Project: IEEE P802.15 Working Group for Wireless Personal Area Networks (WPANs)

Submission Title: [Comment resolution on the color function support]

Re: [Response to the SB 1st recirculation for the IEEE 802.15.7 standard]

Comment resolution on the color function support

Figure 36—CVD frame usage for acknowledgment indication

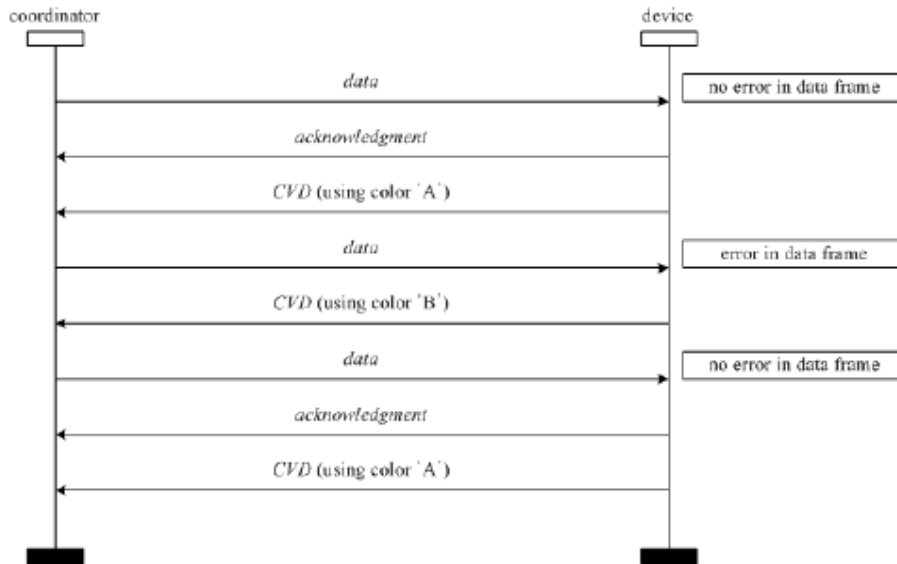
Comment No.	Name	Page	Subclause	Line	Comment	Proposed Change
80	Walewski, Joachim	67	5.1.12.2	29	Sloppy grammar?	Replace "receives some data" with "receives data"

- Change “Figure 36 shows an example of how the user can infer whether a receiver successfully receives **some** data or not.” on line 29, page 67 to “ Figure 36 shows an example of how the user can infer whether a receiver successfully receives ~~**some**~~ data or not.”

Figure 36—CVD frame usage for acknowledgment indication

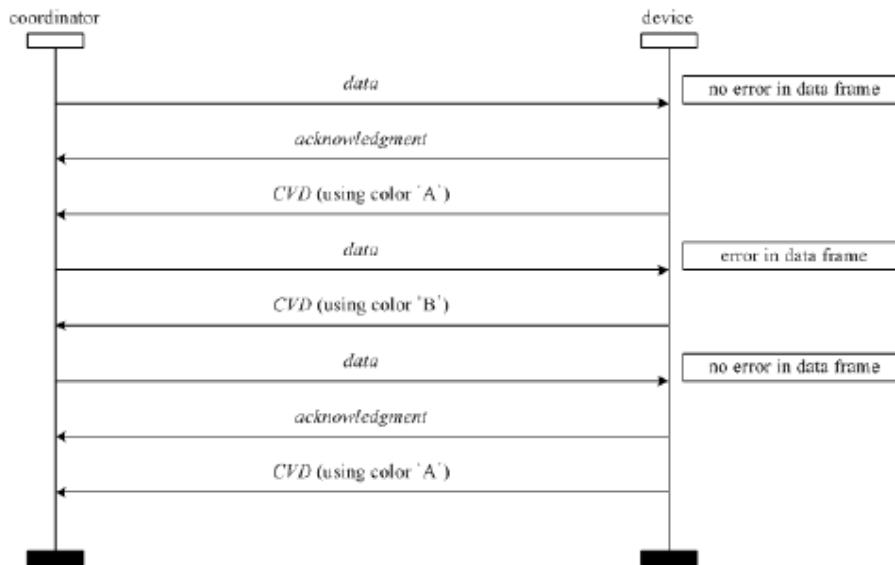
Comment No.	Name	Page	Subclause	Line	Comment	Proposed Change
81	Waleski, Joachim	67	5.1.12.2	30	Uneven style.	Replace "According to Figure 36, the device sends the CVD frame after the ACK frame has been sent." with "According to THIS FIGURE, the device sends A CVD frame ..." (Capitals: my emphasize.)

- Change “According to **Figure 36**, the device sends **the CVD** frame after the ACK frame has been sent.” on line 30, page 67 to “According to **this figure**, the device sends **a CVD** frame after the ACK frame has been sent.”

Figure 36—CVD frame usage for acknowledgment indication

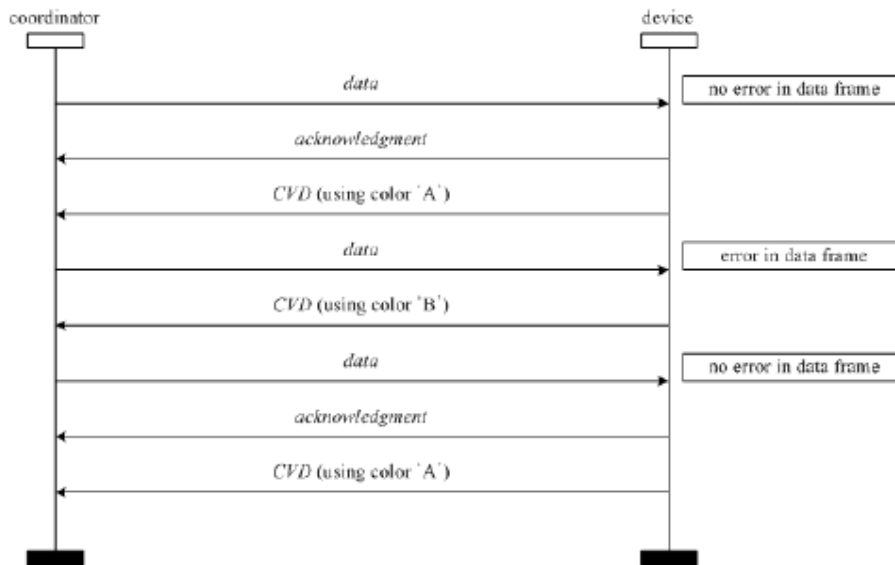
Com ment No.	Name	Page	Subcla use	Line	Comment	Proposed Change
82	Wale wski, Joach im	67	5.1.12 .2	31	Sloppy grammar?	Replace "received data has some errors" with "received data has errors".

- Change "The CVD frame can indicate that the received data has some errors or is error-free, based on the choice of colors." on line 31, page 67 to " The CVD frame can indicate that the received data has ~~some~~ errors or is error-free, based on the choice of colors."

Figure 36—CVD frame usage for acknowledgment indication

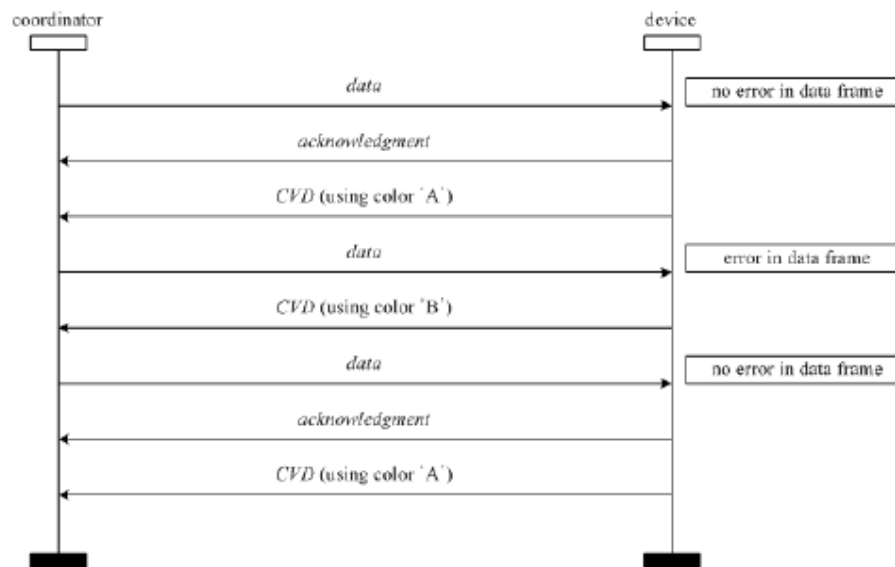
Com ment No.	Name	Page	Subcla use	Line	Comment	Proposed Change
83	Wale wski, Joach im	67	5.1.12 .2	32	How can the CVD frame use anything: "the color function for the ACK state indication is used by the CVD frame"	Change wording. Example: "the color of the CVD frame is set according to the ACK-state indication"

- Change "The MAC PIB attribute, *macColorReceived* as shown in Table 59, is used for the color assignment of the CVD frame when the ACK frame is sent and the color function for the ACK state indication is **used** by the CVD frame." on line 33, page 67 to " The MAC PIB attribute, *macColorReceived* as shown in Table 59, is used for the color assignment of the CVD frame when the ACK frame is sent and the color function for the ACK state indication is **achieved** by the CVD frame."

Figure 36—CVD frame usage for acknowledgment indication

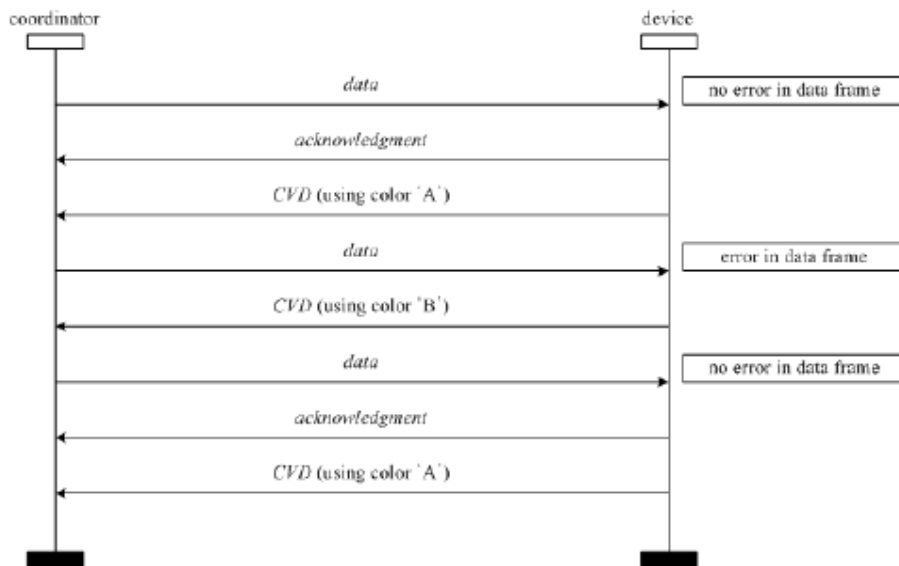
Com ment No.	Name	Page	Subcl ause	Line	Comment	Proposed Change
84	Wale wski, Joach im	67	5.1.1 2.2	33	I simply do not comprehend the last sentence of this paragraph.	Rewrite sentence so that it makes sense. I offer to draft a resolution in concert with the authors of the paragraph.

- Change "The MAC PIB attribute, *macColorNotReceived* as shown in Table 59, is used for the color assignment of the CVD frame when the ACK frame is not sent but the color function for the non-ACK state indication is **used** by the CVD frame." on lines 34 to 36, page 67 to "The MAC PIB attribute, *macColorNotReceived* as shown in Table 59, is used for the color assignment of the CVD frame when the ACK frame is not sent but the color function for the non-ACK state indication is ~~used~~ **achieved** by the CVD frame."

Figure 37—Example of MSC for CVD frame usage for file-transfer status indication

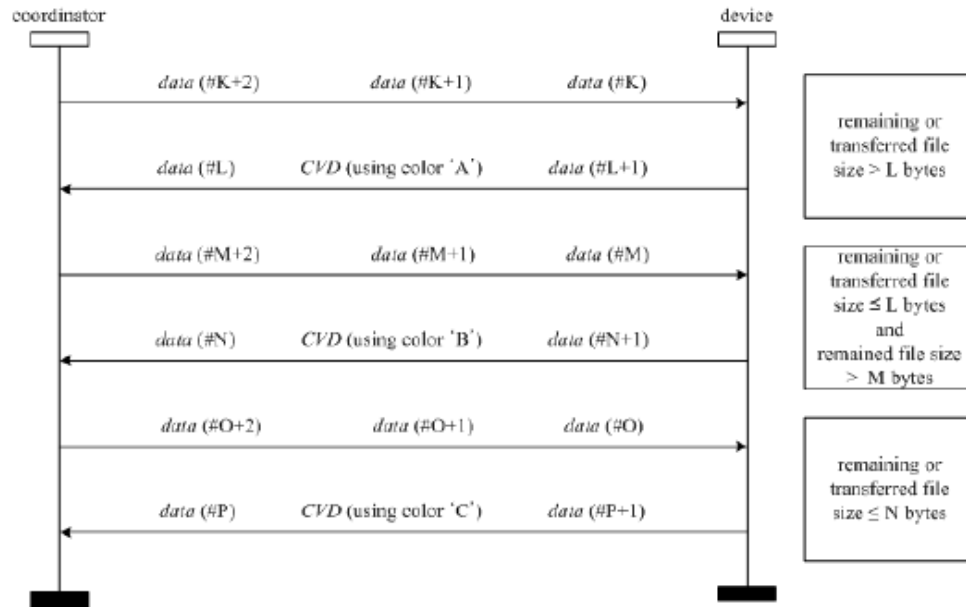
Com ment No.	Name	Page	Subcl ause	Line	Comment	Proposed Change
85	Wale wski, Joach im	68	5.1.1 2.4	42	Confusing indication of a qualifying sentence, while the sentence actually is not qualifying.	Replace "For example, in order to use ..." with "In order to use ..."

- Change " **For example, in order to use this indication** the device needs to know the total file size to be transmitted." on line 42 in page 68 to "**In order to use this indication**, the device needs to know the total file size to be transmitted."

Figure 35—Example of CVD frame usage MSC for association

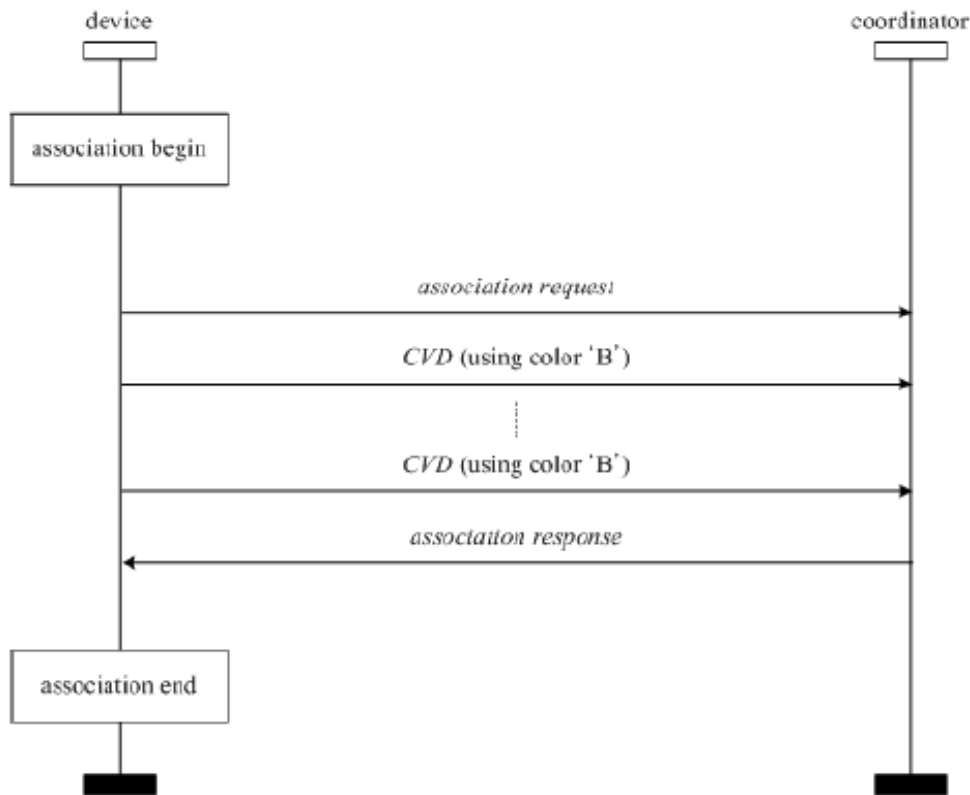
Com ment No.	Name	Page	Subcla use	Line	Comment	Proposed Change
313	Wale wski, Joach im	66	5.1.12 .1	11	This sentence reads rather awkwardly.	Replace "using a chosen color." with "and indicates this to the user with a chosen color."

- Change "For example, the device sends an association request to the coordinator (see Figure 35) **using a chosen color.**" on line 11 in page 66 to "For example, the device sends an association request to the coordinator (see Figure 35) **and indicates this to the user with a chosen color.**"

Figure 35—Example of CVD frame usage MSC for association

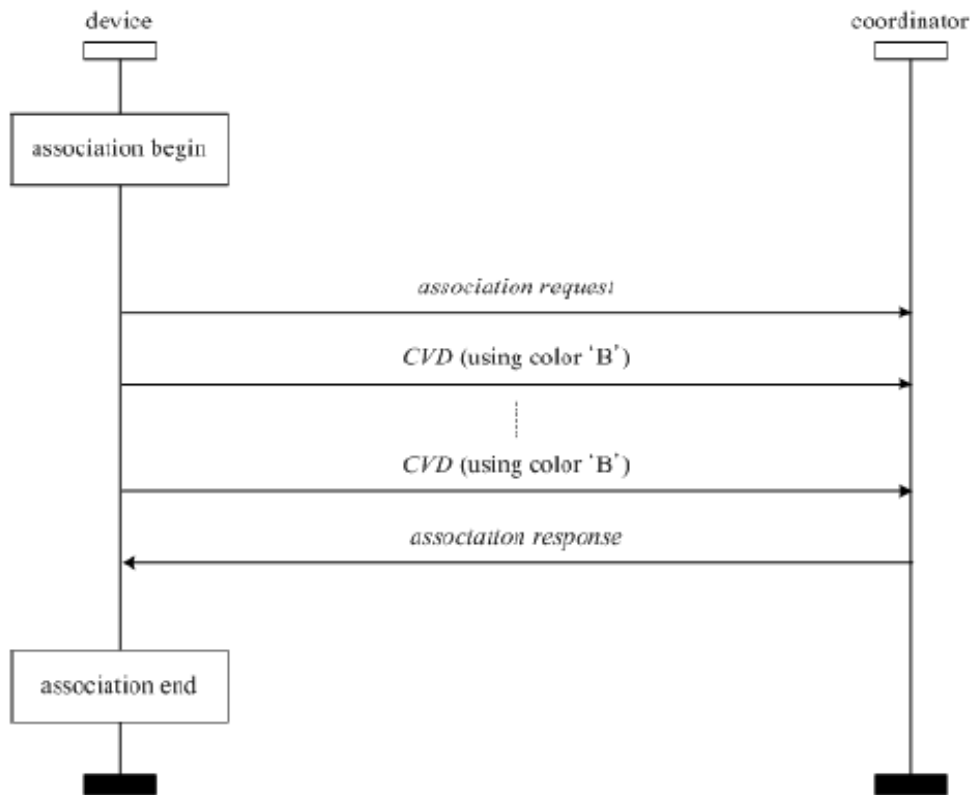
Com ment No.	Name	Page	Subcla use	Line	Comment	Proposed Change
314	Wale wski, Joach im	66	5.1.1 2.1	42	This Figure caption reads rather awkwardly.	Replace "Example of CVD frame usage MSC for association! with "MSC for association when color- function-support is invoked."

- Change “Figure 35—Example of CVD frame usage MSC for association” on line 42, page 66 to “Figure 35—**MSC when color function for association indication is invoked**”
